Technical Service Bulletin

Topic	Bentley Rotational Display (BRD) clashing with the switch pack during rotation
Market area	Bentley: worldwide (2WBE),China 796 VW Import Comp. Ltd (Vico), Beijing (6796)
Brand	Bentley
Transaction No.	2075740/2
Level	EH
Status	Released for publishing
Release date	Sep 24, 2025

Bentley Rotational Display (BRD) clashing with the MMI switch pack during rotation

Figure 2

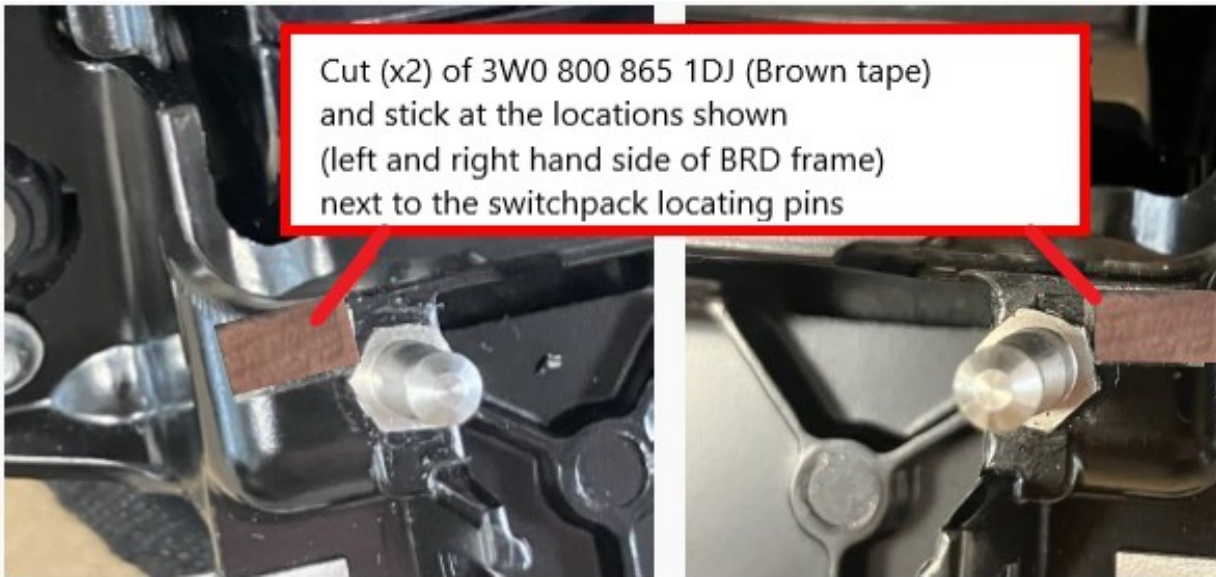
3) Referring to Figure 2 - Cut (x2) of 3W0 800 865 1DJ (Brown tape)

- Ensure the surface of the BRD frame is clean - Apply the tape at the locations shown on left and right hand side of BRD frame (next to the switch pack locating pins)

Figure 3

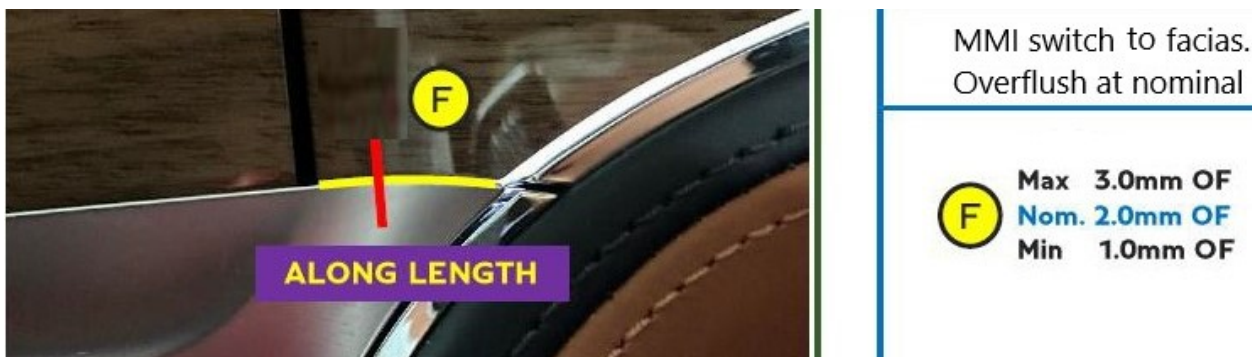
5) Referring to Figure 3 - Measure the profile of the switch pack to confirm the correct tolerance has been achieved

- Should the required tolerance be achieved - Rotate the BRD with care to confirm the issue is resolved
- If resolved no further action is required
